BEA 050/250/350/450/840/850

Introduction of Andros-measuring chamber

Replacement of a Siemens-measuring chamber within the **warranty** period

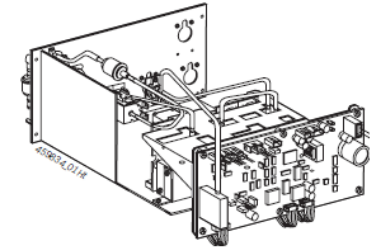
If a Siemens measuring chamber breaks down within the warranty period, then a Siemens-measuring chamber **1 682 666 003** has to be ordered and installed.
